Re: *Comments of the Massachusetts Port Authority on the United States
Environmental Protection Agency (EPA) Proposed Effluent Limitation Guidelines
and New Source Performance Standards for the Airport Deicing Category
Docket No. EPA-HQ-OW-2004-0038*

**Proposed Rulemaking for Effluent Limitation Guidelines and New Source Performance
Standards for the Airport Deicing Category
74 *Fed. Reg.* 44,675 (August 28, 2009)**

Docket No. EPA-HQ-OW-2004-0038

Massachusetts Port Authority

Figure 6. Boston Logan Major Runway Configurations

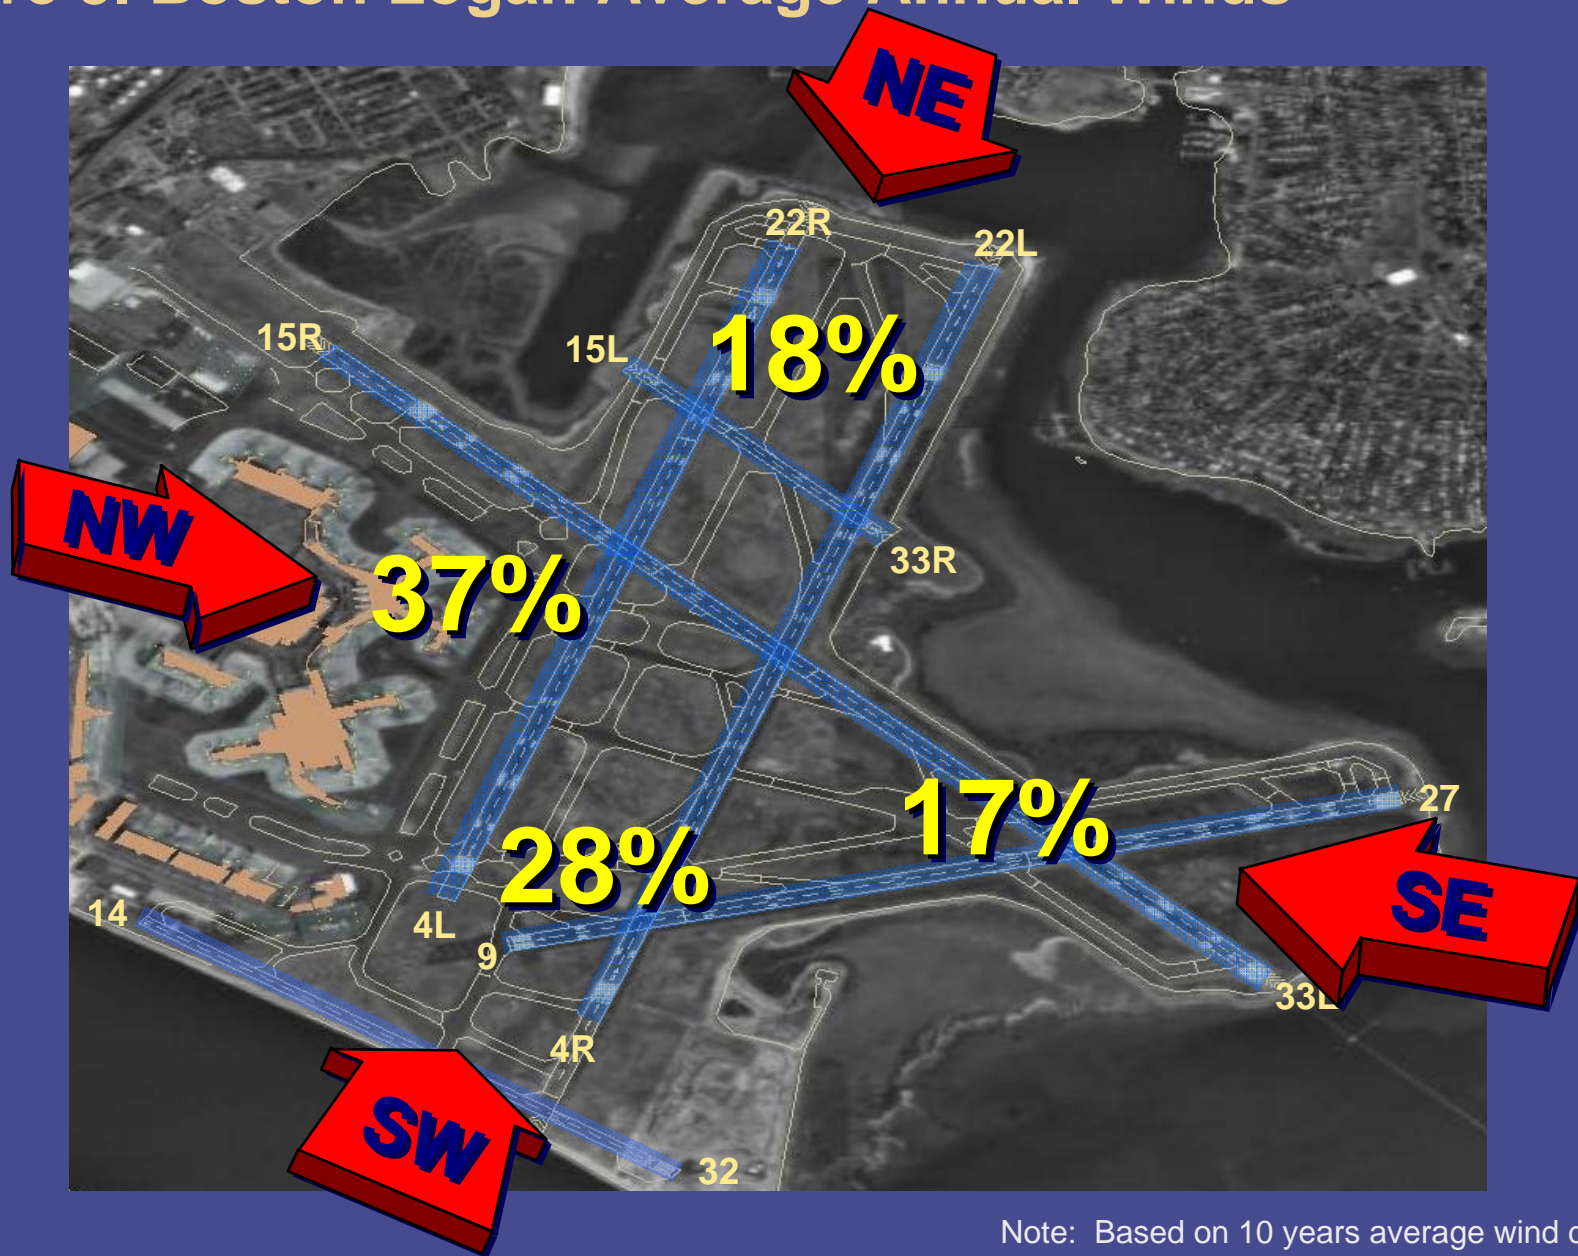
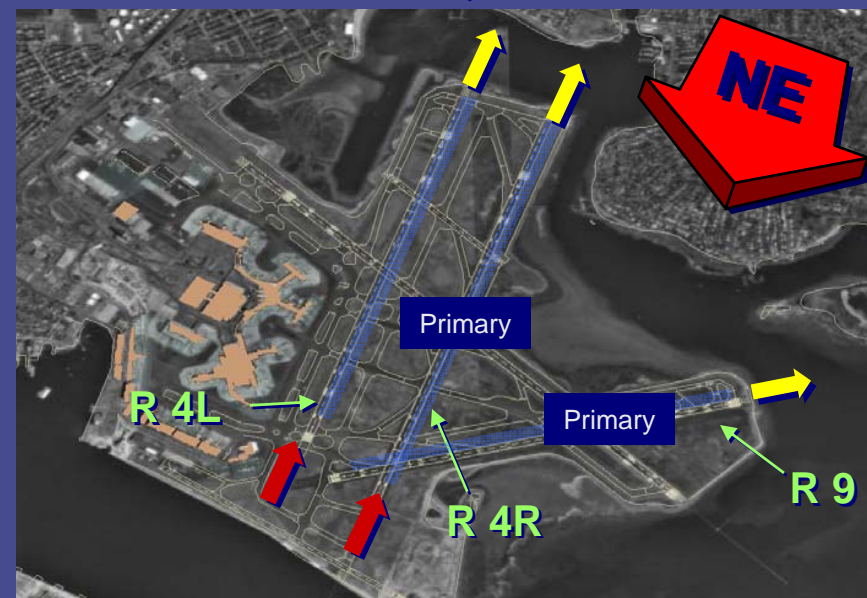
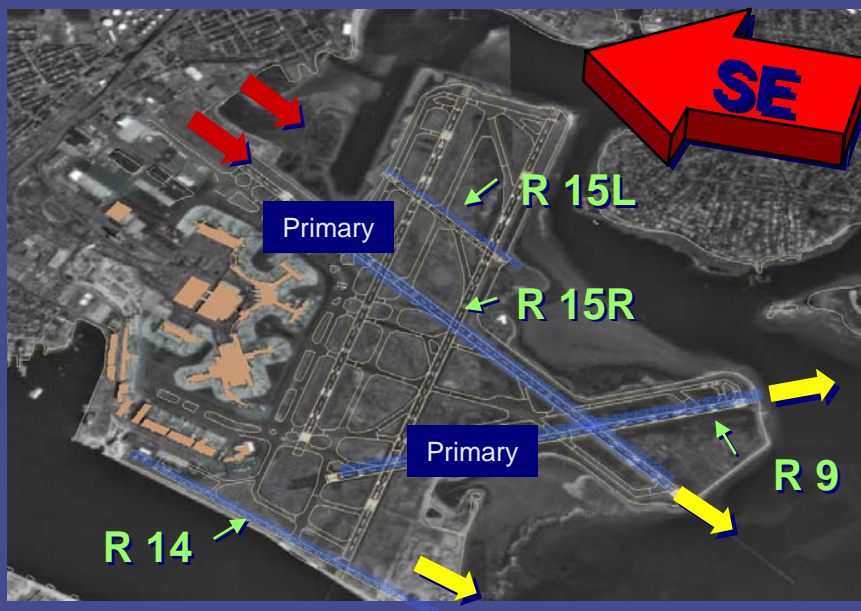
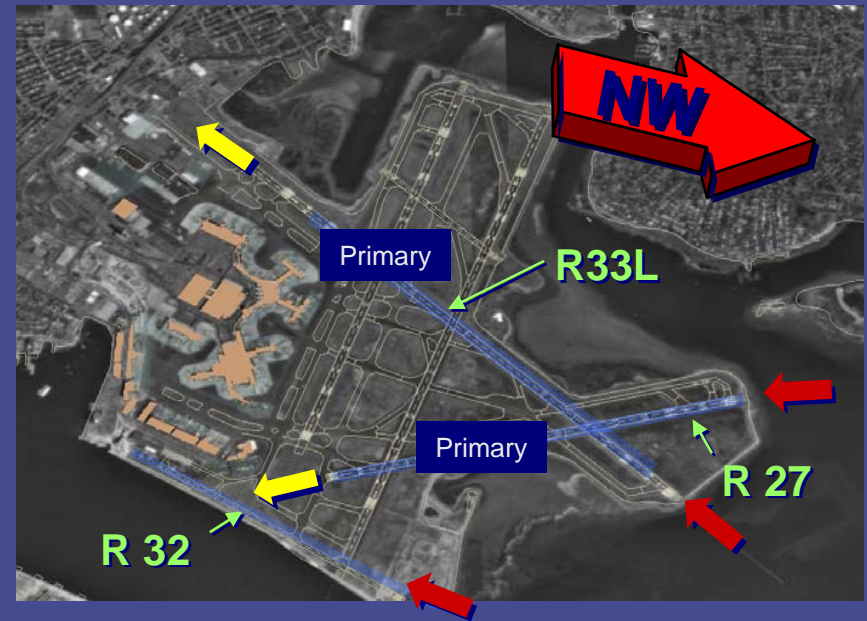
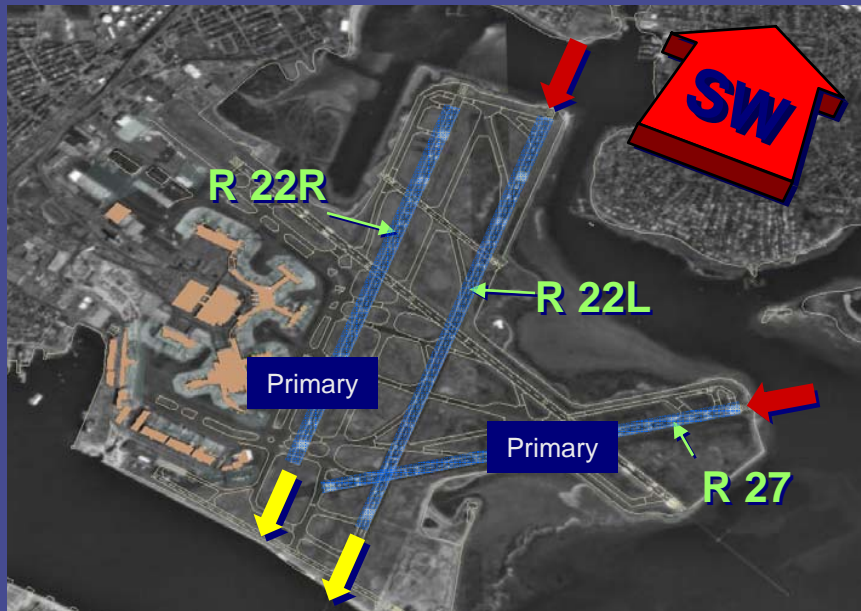
Based on all of these factors, departing aircraft typically must use the following runway configurations during the following wind conditions (as depicted graphically in Figure 6):

FIGURE 7
CENTRALIZED DEICING PAD
LOCATION PLAN

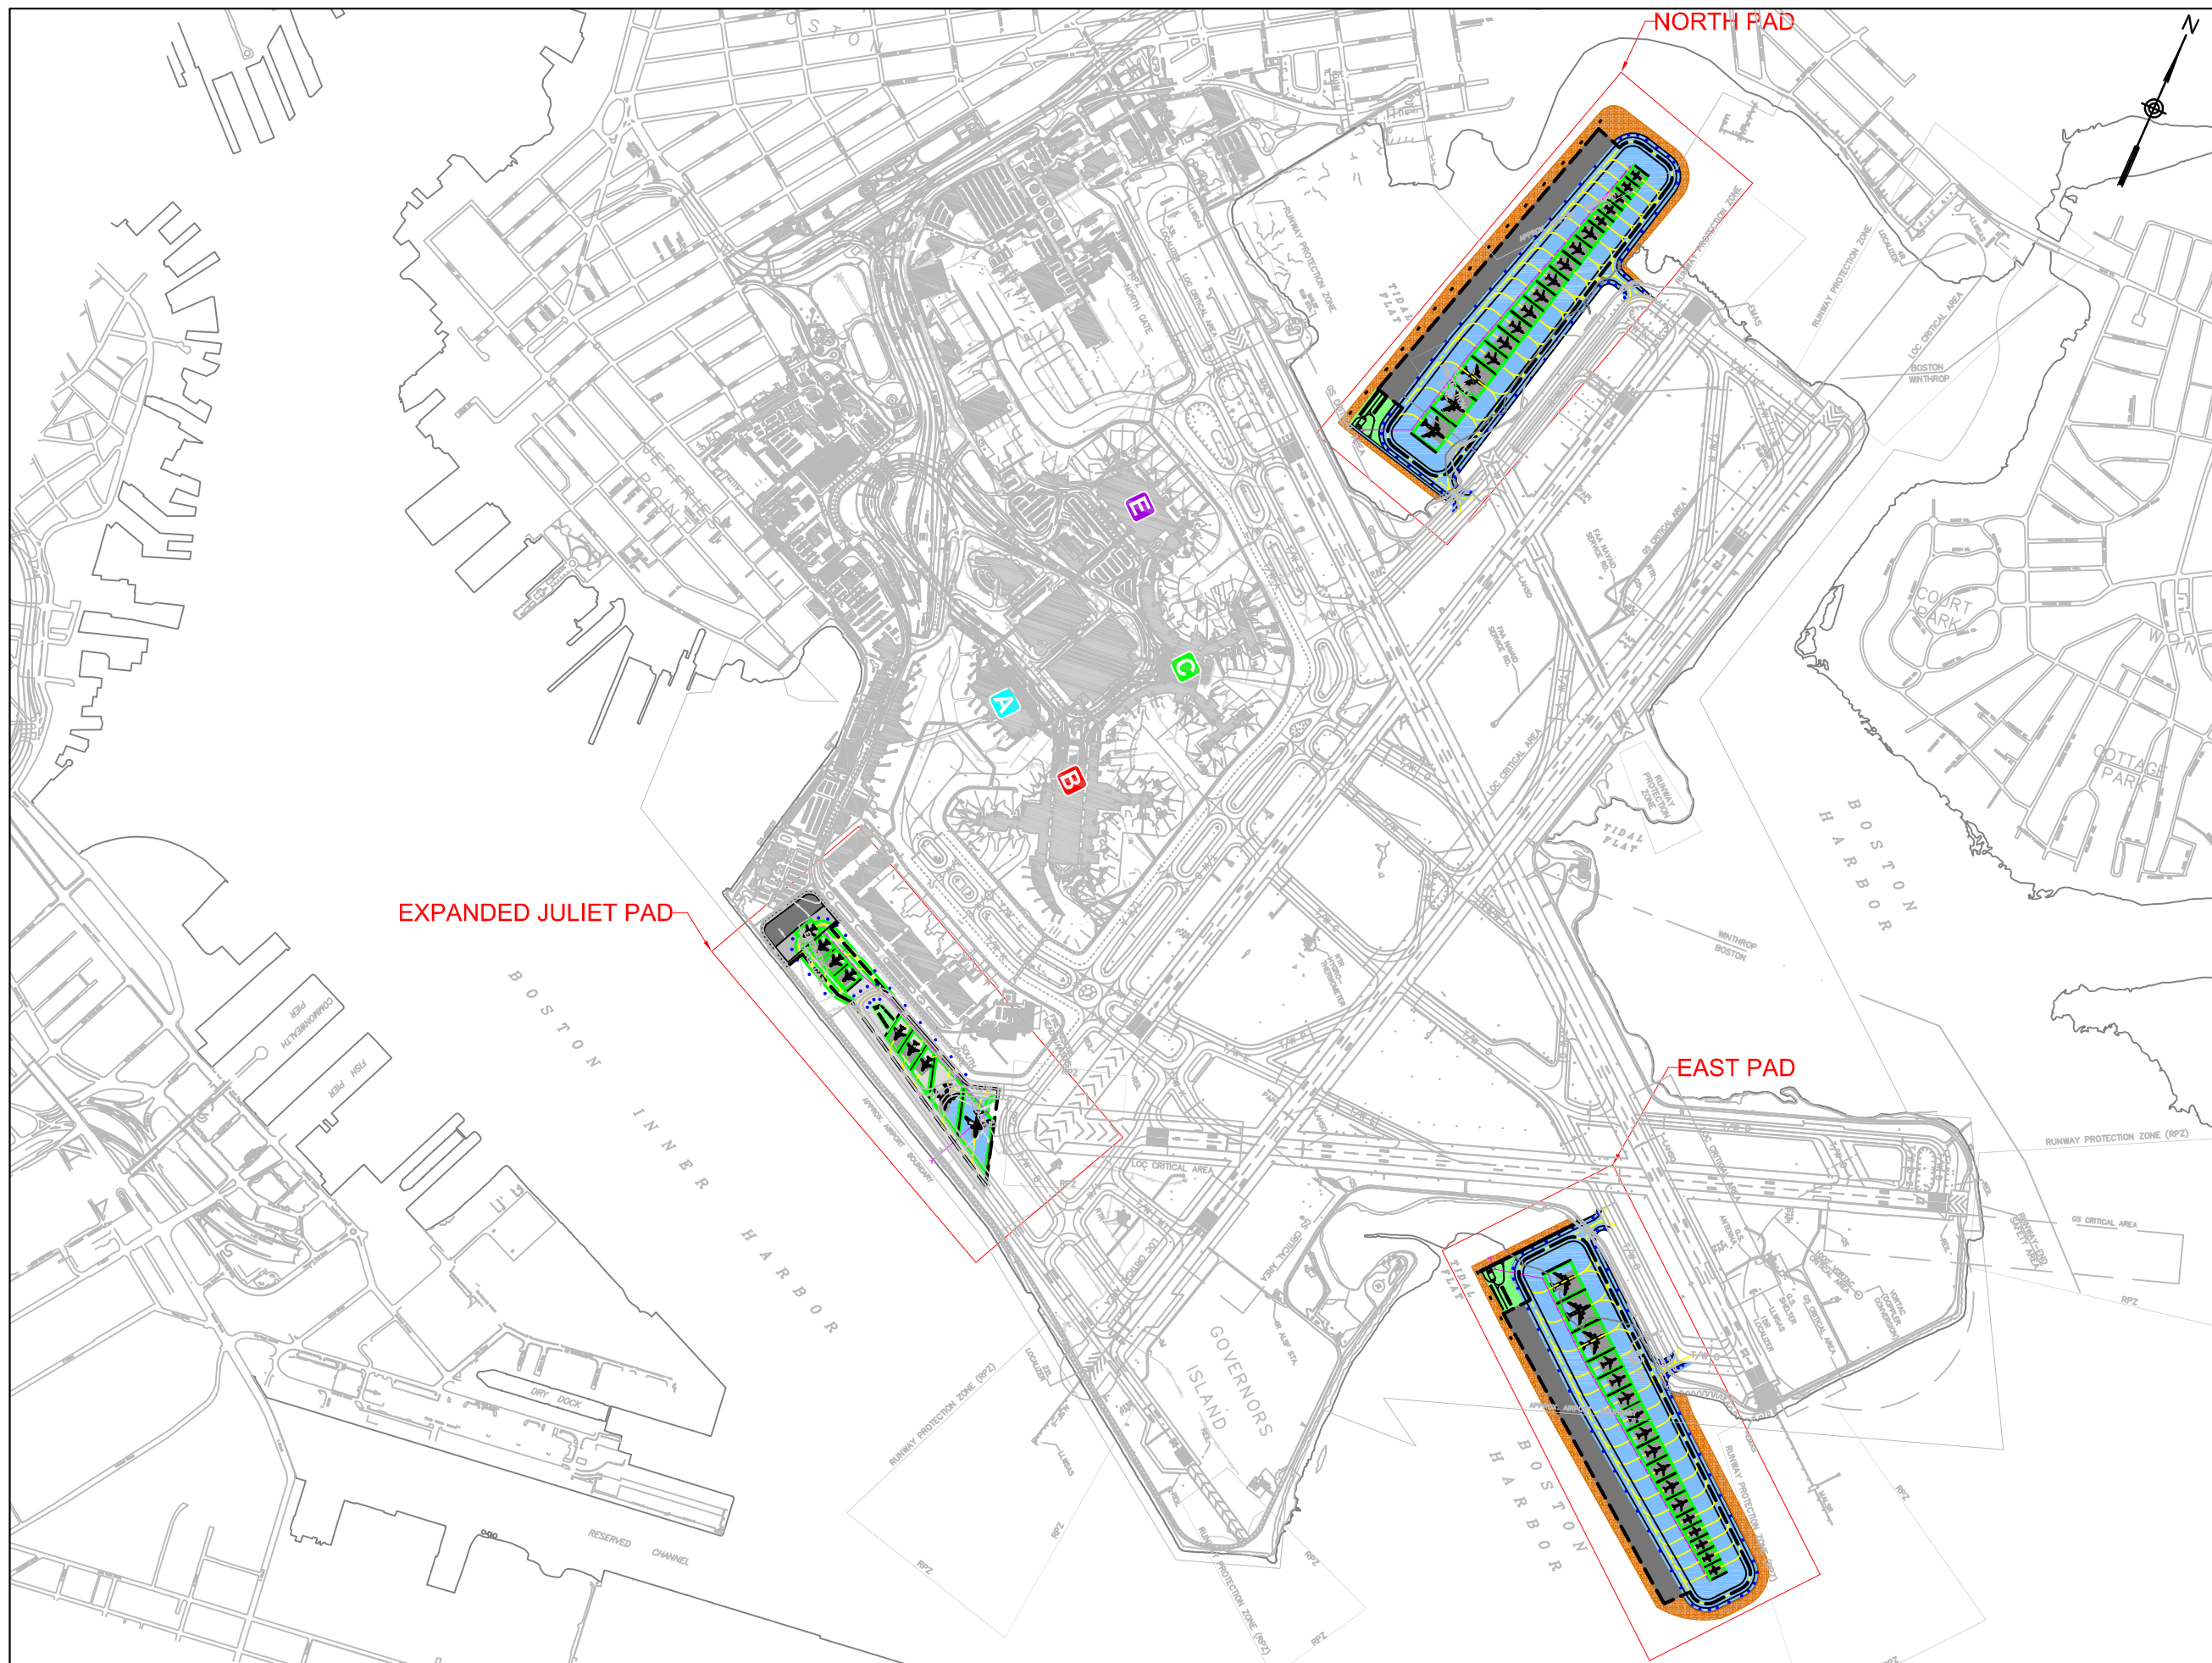
- North Pad: The North Pad would include 17 deicing positions laid out in accordance with FAA requirements, a 91,000 square foot support facility pad to provide staging areas for equipment, materials and support facilities and a 2,805,000 square foot spent ADF collection area (including a 500,000 square foot snow storage area), for a total pad area of 2,896,000 square feet. Because the North Pad’s purpose would be to deice all aircraft departing from Runways 22L, 22R, and 15R, and because of the lack of existing, open land area in the vicinity of the ends of those runways, it was determined that the only possible location for the North Pad would be in the Boston Harbor (Winthrop Bay) tidelands near the approach end to Runway 22R, as shown in Figure 7. In fact, to build the North Pad, about 3,609,660 square feet, or
